SITE: Land to the south of Lower Bullingham west of the Rotherwas Industrial Estate north of the Rotherwas Hereford HR2 6JW

DESCRIPTION: The first phase of an urban extension (known as the Southern Urban Expansion in the Herefordshire Local Plan Core Strategy) comprising up to 540 homes (Use Class C3); employment land (Use Class B and E)

APPLICATION NO: 242558

Flood Risk

Ordinary Watercourses and River Wye Impact Analysis 5 year

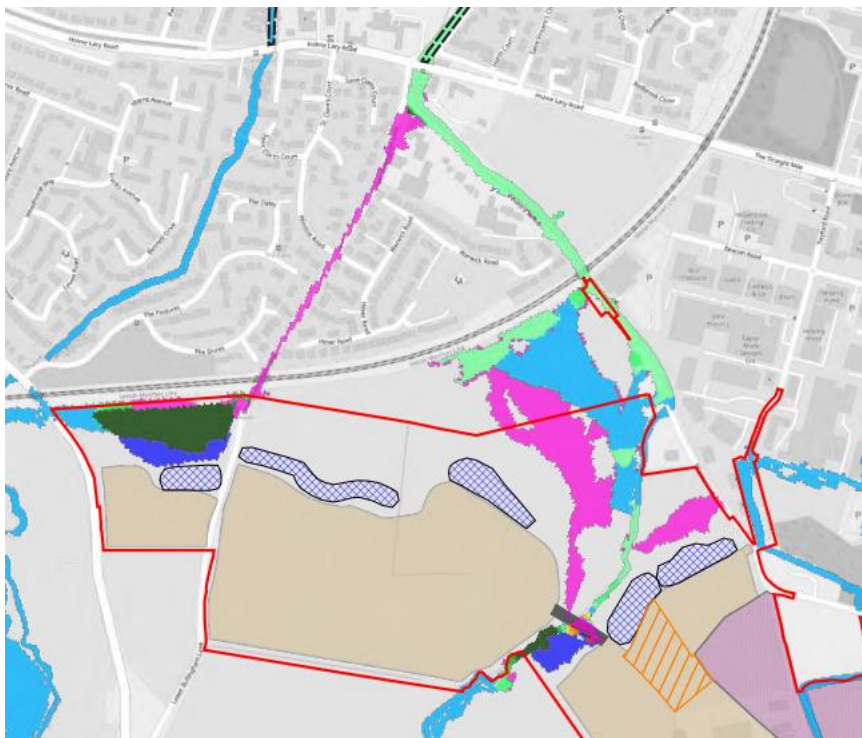
The flooding at Green Crize railway bridge occurs because the road is lower than farmland. This road access will always be at risk of closure.

The Withy Brook bursts its banks at an existing farm access culvert. The land is owned by Bloor Homes. The applicant needs to present a long term solution that will address this risk and provide assurance that the fluvial flow will not spill across the field to the road. This needs to be addressed as part of the Outline planning application and implemented without delay. This should be regarded as effective riparian management, not a contribution to flooding deficiencies.

The flooding of Green Crize can also occur due to the high soffit level of the railway culvert which limits flow capacity in higher return events.

Ordinary Watercourses Impact Analysis - 50 year

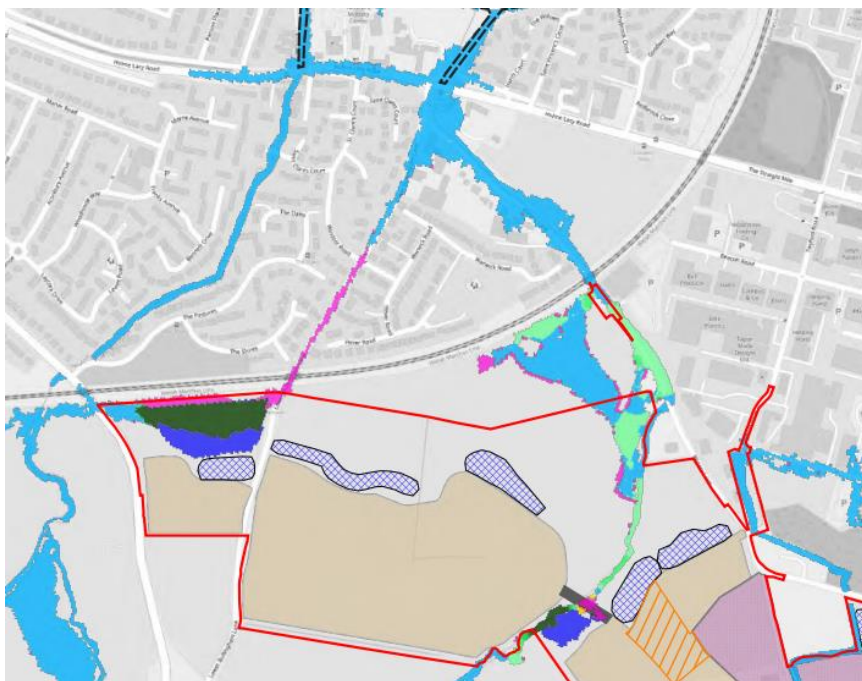
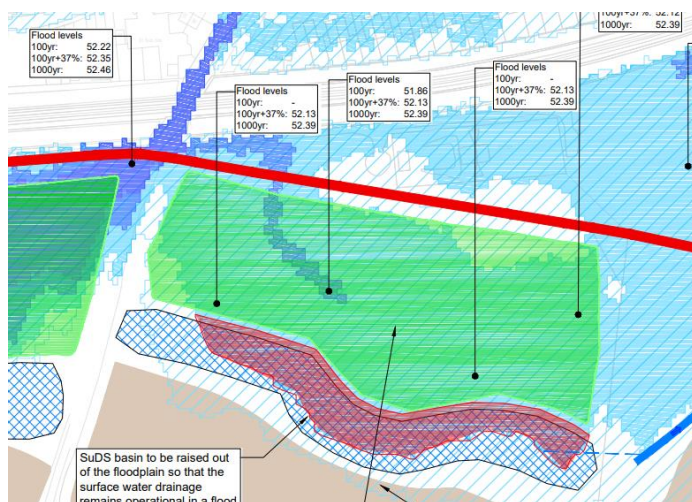
The modelling does not include the raised ground at Windsor Road. The results suggest that following the development, Lower Bullingham Lane will become a dry access route. Given that road levels are higher up than modelled, there will be an ongoing access issue.

The provision of upstream attenuation adjacent to the flow route (Flood Compensation location 3) will only have the effect of reducing the flow rate down Lower Bullingham Lane until the compensation area fills with water. The problem of flooding on the lane arises because flood water is trapped there. This is not reflected in the modelling results.

To address the issue of pedestrian access during and after floods, we consider that off-site works could be delivered by the developer to improve the profile of Lower Bullingham Lane so that water is not retained after a flood. Improvements could also be made to the highway drainage.

Ordinary Watercourse with River Wye Impact Analysis 30 year

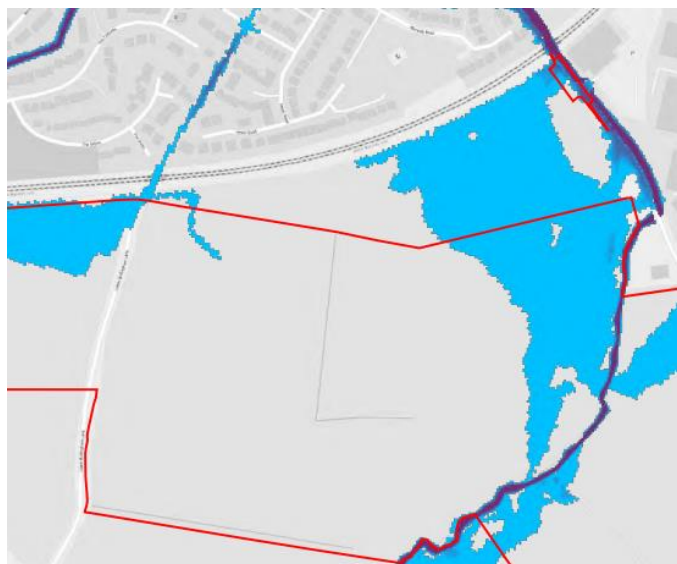
During floods, water spills from the Withy Brook along the edge of the railway and discharges under the railway bridge onto Lower Bullingham Lane.

The model results show that the flood storage area north of the proposed SuDS Basin (Location 1) will only flood from the Wye during an exceptional flood event (100 year + 37% CC). This area is not shown as flooded during a 100 year event.

Figure 4.6: Backwater Influence from the River Wye – 1 in 100-year + 37%

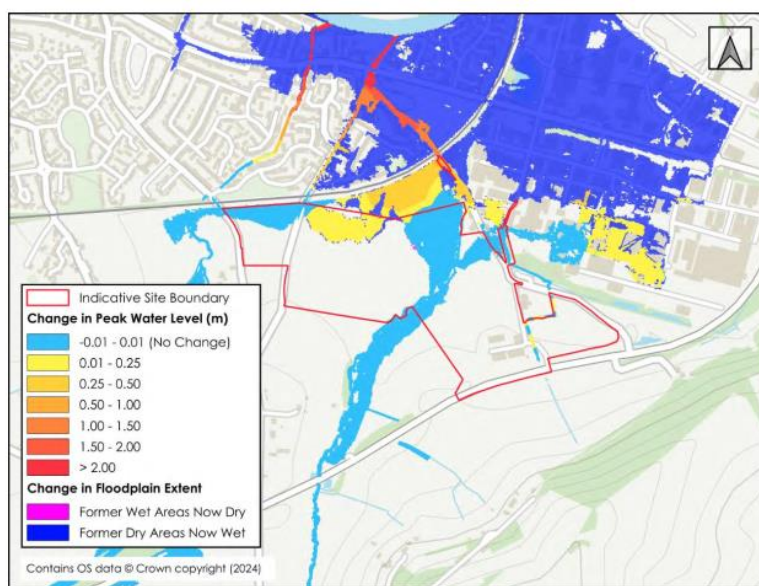
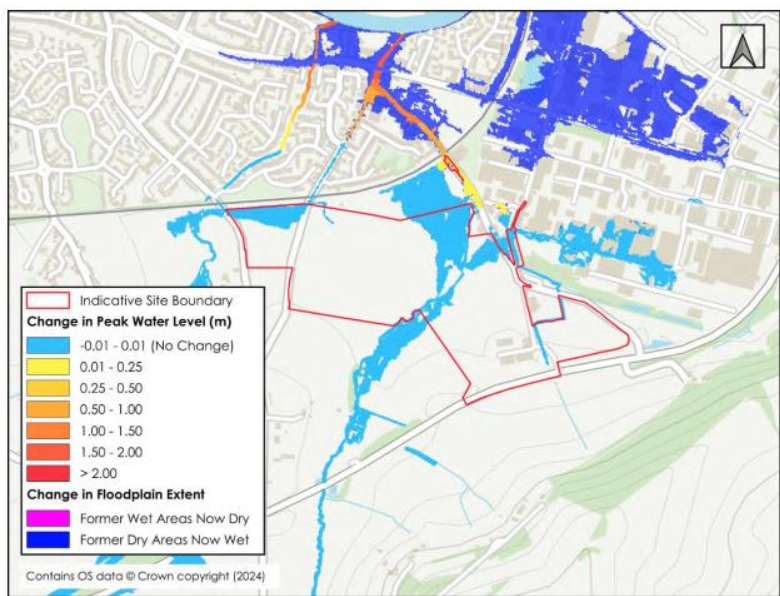
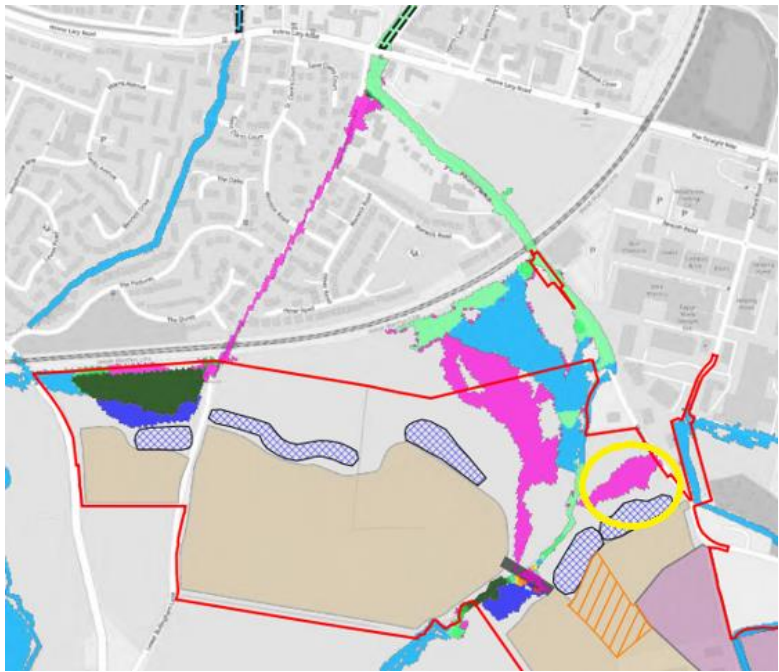
The water level difference mapping does not show this area as having flooded. We recognise that compensatory storage has been provided because a basin is proposed here, but we are unclear why it has been assumed that the flood storage will provide downstream benefits. We recognise that there is a low lying paved path alongside the railway, which could flood with shallow water but most water drains below the bridge.

Ordinary Watercourses Impact Analysis - 50 year

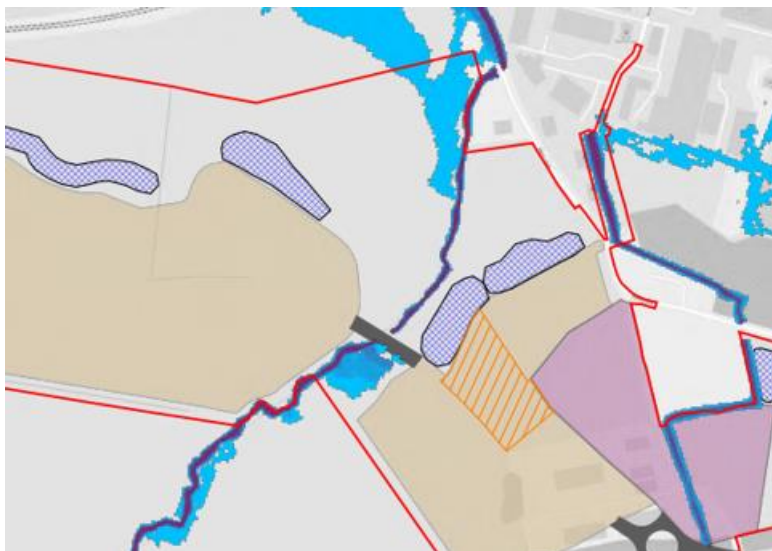
The modelling results show flow spilling from the right bank of the Red Brook but only in acute storms of 50 year return (the 30 year plots do not show this route).

We note the proposals for a new access bridge (with a 450mm dia overflow) that would throttle flows on the Red Brook, with the intent of attenuating water in Flood Compensation Location 2. We respect that the purpose of the compensation area is to facilitate construction of the bridge within Flood Zone 3. However, it is clear from a review of the flood storage table that most of the storage volume is low down and so would be flooded mid-way through a storm. Whilst the developer is offering additional storage, due to the forementioned issue there may be a limited impact on downstream flood risk.

Conversely, the Impact Analysis plots show marginal reductions in flood depth on Watery Lane in all flood events. All results are similar, but there is no explanation as to why these benefits arise in small events.

The mapping does specifically show the difference in flood depth as between 50mm and 25mm. if there are any benefits then they have been proven to be marginal in scale.

Ordinary Watercourses and River Wye – Baseline 30 year

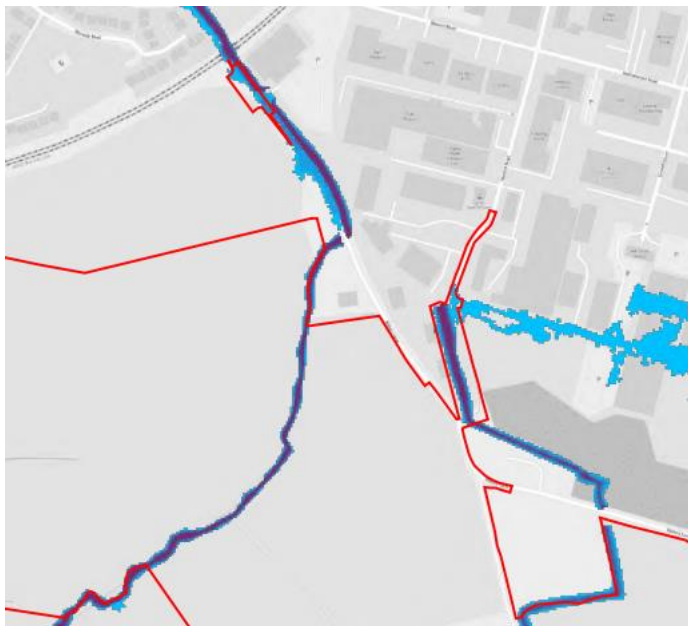
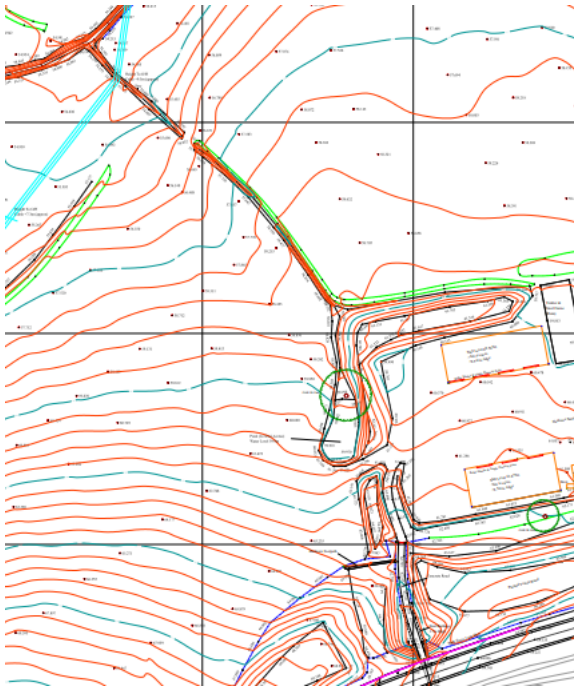
The Red Brook can cause flooding issues in the vicinity of this area of the Rotherwas Industrial Estate, most likely in storms more intense than 5 years

Please clarify which cross sections of the watercourse were surveyed in this area. The ditch from the scrap yard discharges into the Red Brook via a series of culverts (below the Caravan Park and then below an industrial premises). Section 2.2 refers to the un-named ditch discharging in the Red Brook. However, it appears that the model shows water from the scrap yard ditch discharging across the surface, to the east. Accordingly, there would be less flow in the Red Brook.

Topographical Survey showing existing ditch discharging into Red Brook

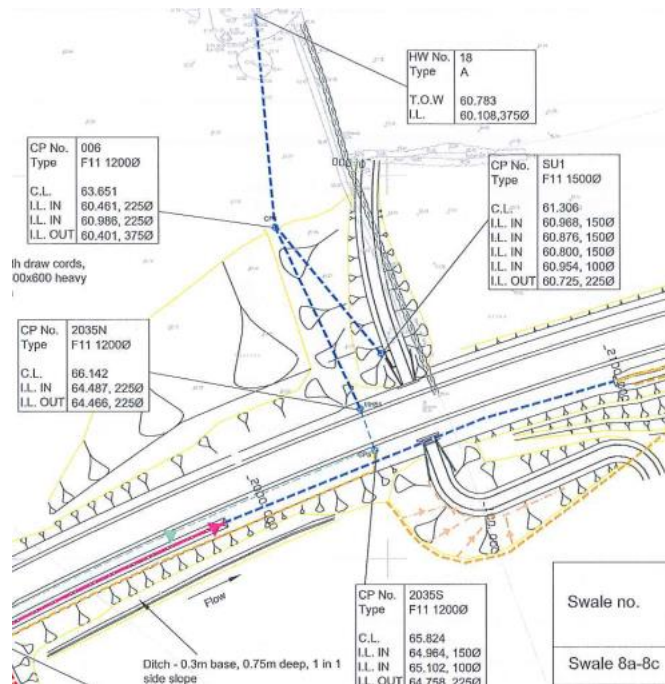
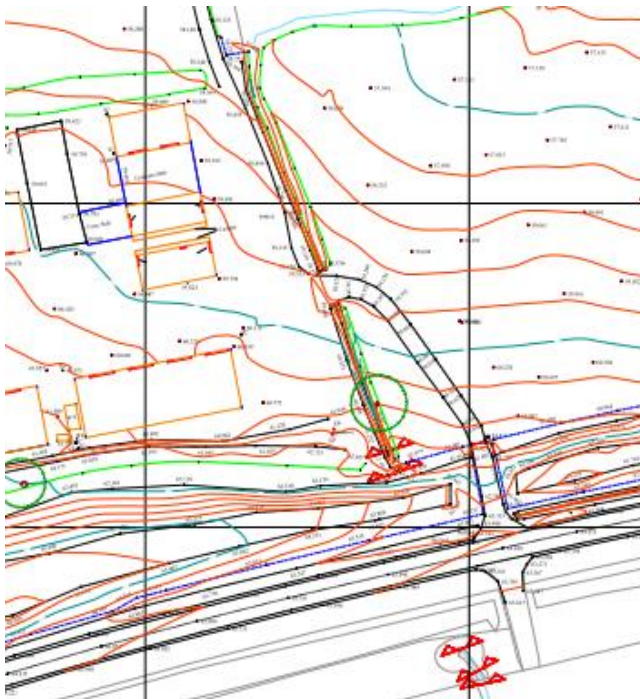
The masterplan does not include provision for the land drainage referenced above.

Topographical Survey showing existing ditch

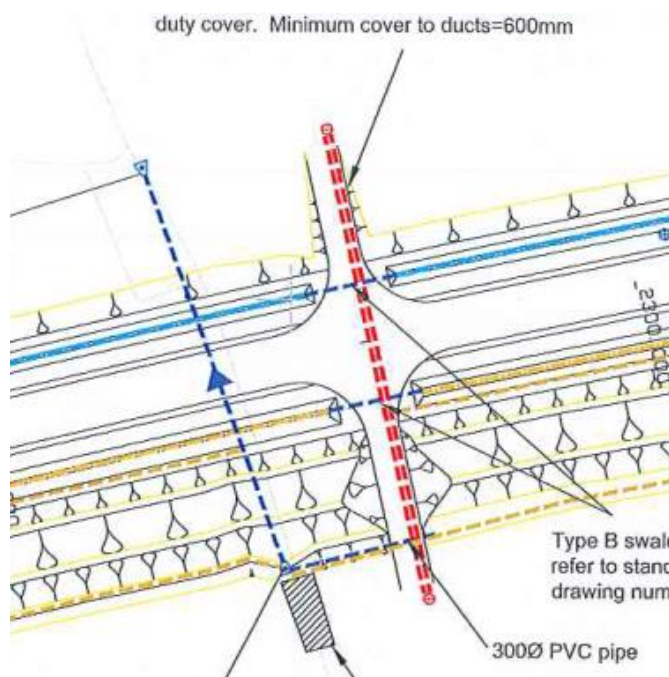
The Illustrative Floodplain Management Strategy does not include for a new culvert below the diverted B4399. We assume that the applicant would seek to extend the existing highway culvert. However, the culvert would become close to an urbanised area, so would require redesign in accordance with the Culvert Design guide. There are no details, there could be ecological issues to consider. It would be impractical to de-culvert a short section on the south side because there is an existing swale there which forms a part of the highway SuDS.

The Conceptual Drainage Strategy drawing does not show the watercourse/ditch that runs anticlockwise around the scrap yard. This is however referred to as a watercourse on the Illustrative Floodplain Management Strategy.

The ditch/watercourse would need to run as open channel alongside the proposed new service road. It is not shown as an open watercourse at the south of the extract below, although the green infrastructure plan does show an open watercourse. We request clarity on this issue, noting that there would be no vehicular access to the area alongside the roundabout.

A strategy for conveying this land drainage below the new B4399 would need to be addressed at Reserved Matters stage.

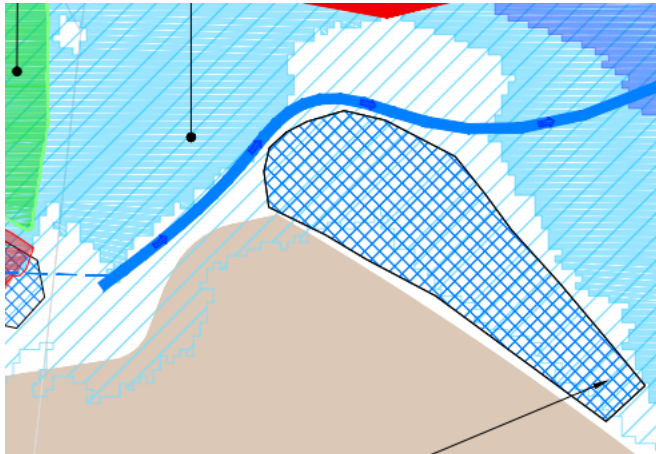
We understand that Flood Compensation Location 1 would fill only in an acute Wye flood. In such an event, water arising from the Wye floodplain would back up this ditch. It would be important to control bank levels so that Flood Compensation Location 1 filled and emptied as the designer intended. Please clarify the extent and level of Flood Compensation Location 1 with respect to this ditch.

The EA have passed comment regarding the location of Flood Compensation Location 1, however our understanding is that this is not in the functional flood plain 3B.
